Productinformatie - Toyota remblokken | HELLA

Toyota remblokken

8DB 355 014-881 vervangt 8DB 355 013-741

Nieuwe remblokken voor bepaalde voertuigen

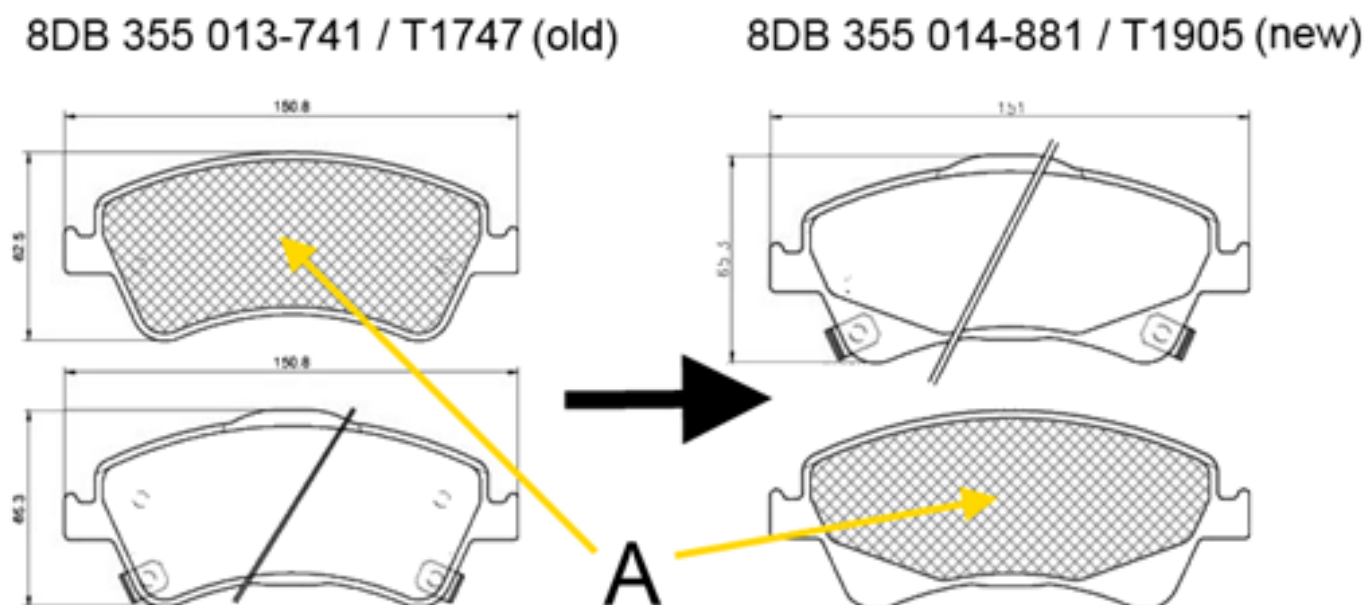
Wegens een verandering in de serieuitrusting door de voertuigfabrikant Toyota heeft de volgende aanpassing plaatsgevonden in de artikelen die voor voertuigen van deze fabrikant worden gebruikt.

Remblok 8DB 355 013-741/T1747 wordt vervangen door remblok 8DB 355 014-881/T1905.

Het zichtbare verschil tussen de beide remblokken is de gewijzigde vorm van de frictievoering (A).

Voor zover het artikel 8DB 355 013-741/T1747 nog op voorraad is, kan dit gewoon verkocht blijven worden.
